SUBJECT: NuScale Power, LLC Response to NRC Request for Additional Information No. 134 (eRAI No. 8934) on the NuScale Design Certification Application

Response to Request for Additional Information Docket No. 52-048

eRAI No.: 8934

NRC Question No.: 03.07.02-13

Figure 3.7.2-34: 3D View of Pool without Water with 12 RXMs

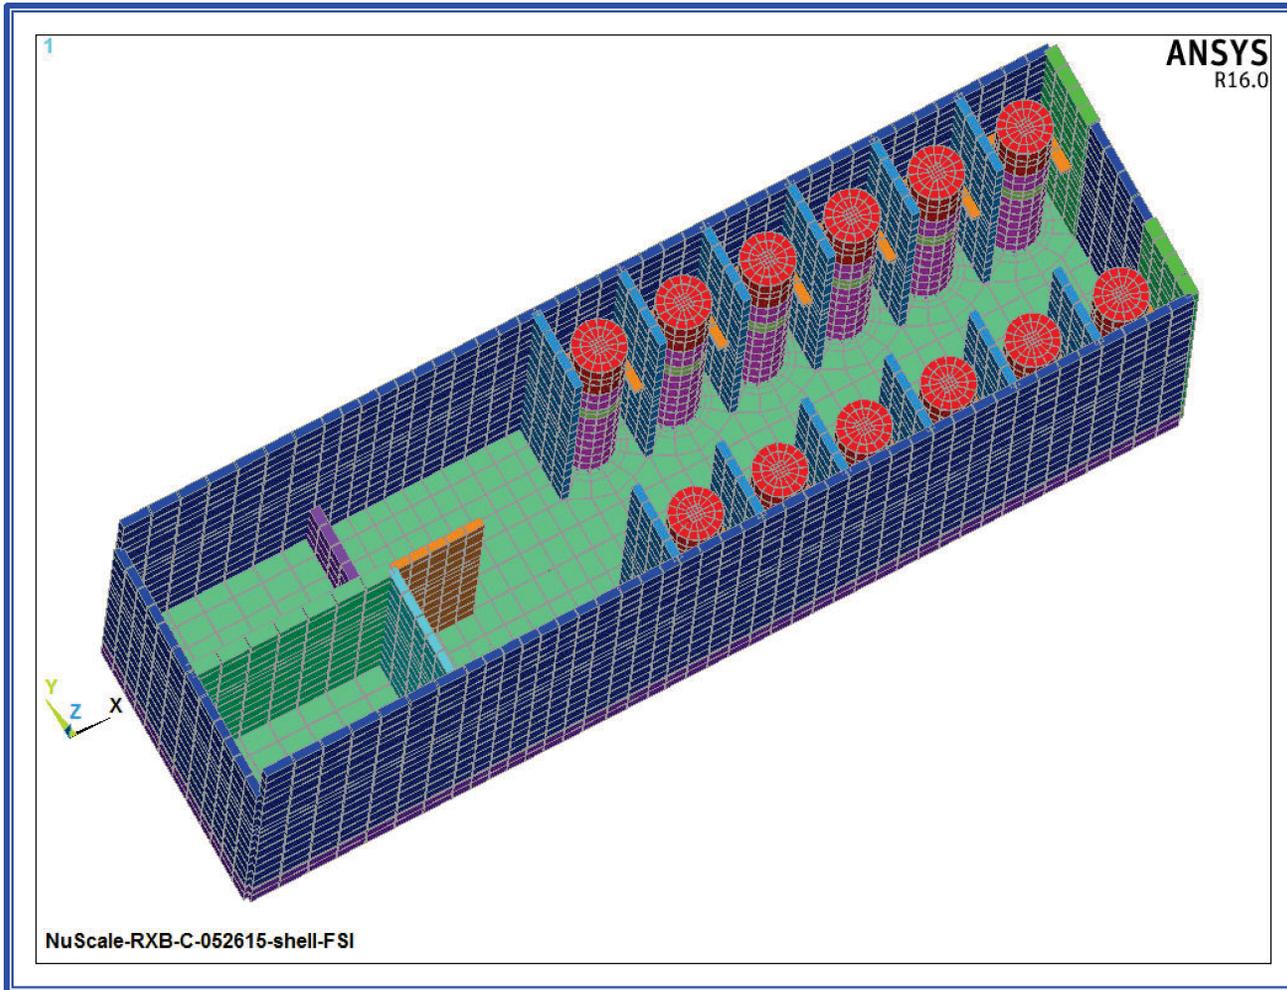
- c. Figure 3.7.2-34 in the FSAR shows a plan view of the wall segments used for fluid-structure interaction (FSI) analysis, and walls separating the refueling pool, spent fuel pool, and dry dock are indicated. However, ANSYS finite elements presented in Figure 3.7.2-33 do not show a wall segment separating the refueling pool and spent fuel pool and a segment separating the refueling pool and dry dock. The applicant is requested to clarify the discrepancy.

- c. A wall segment separating the refueling pool and spent fuel pool and a segment separating the refueling pool and dry dock are included in the ANSYS model. They are hidden by the fluid elements shown in FSAR Tier 2, Figure 3.7.2-33. A new figure, Figure 3.7.2-34, will be added to FSAR Tier 2, Section 3.7.2 to show these details.

The ANSYS model used for this evaluation is shown in ~~Figure 3.7.2-32 and Figure 3.7.2-33~~ Figure 3.7.2-32, Figure 3.7.2-33 and Figure 3.7.2-34. For the ANSYS model, the z ordinate is at the top of the pool water, instead of the base of the foundation, which is used for the building analyses in SAP2000 and SASSI2010. For the ANSYS model, the z ordinate is at the top of the pool water, in order to define the location of the free water surface in the FSI analysis, instead of at the base of the foundation, which is used for the building analyses in SAP2000 and SASSI2010.
